Service Bulletin

Cleat Pin Backing Out On Triple Link Pedals

Applies to: Schwinn Triple Link Pedals

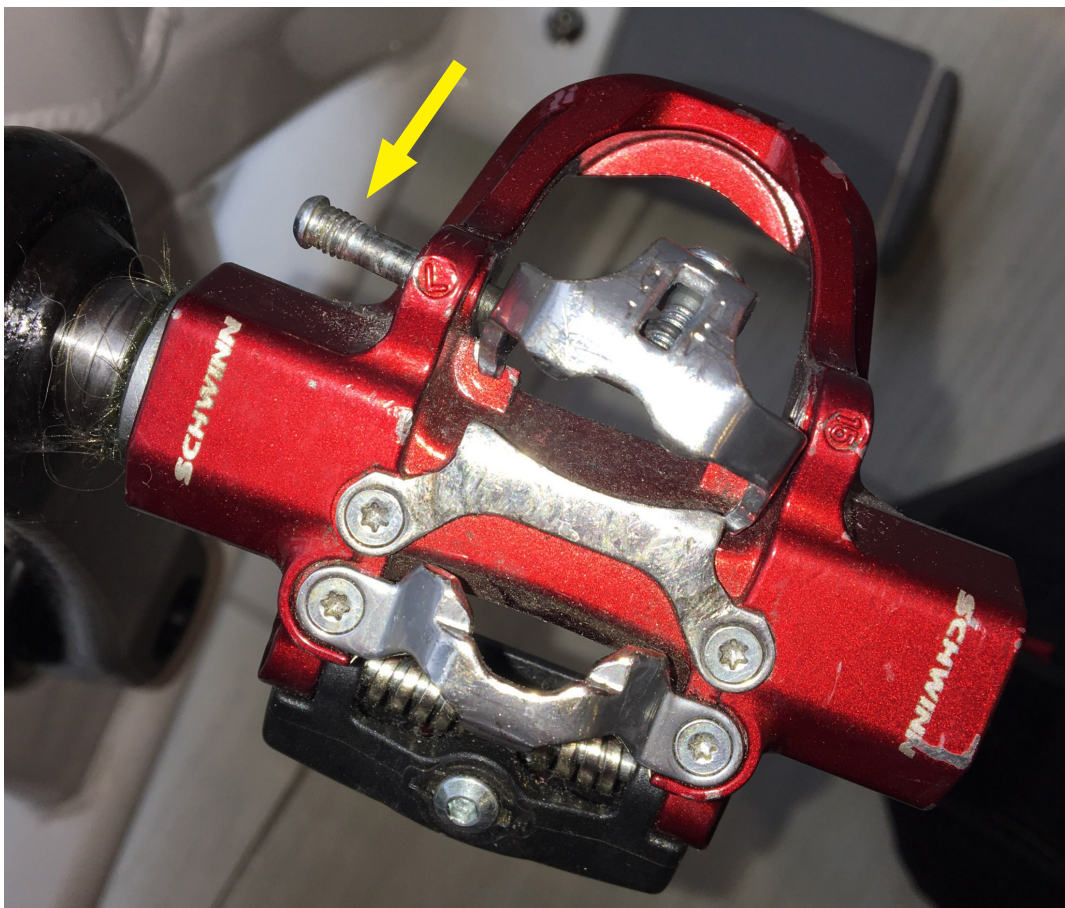
On some Schwinn Triple Link Pedals, an issue has been identified where the pin that holds the pedal cleat to the pedal body can back out, rendering the clip inoperable. Please see image below.

If this occurs, the pedal will need to be replaced:

740-8825: 9/16" Threaded Triple Link Pedal Set.

740-8689: Morse Taper Triple Link Pedal Set w/SPD + LOOK Delta clip.

718-5869: Morse Taper Triple Link Pedal Set w/SPD + LOOK KEO clip.
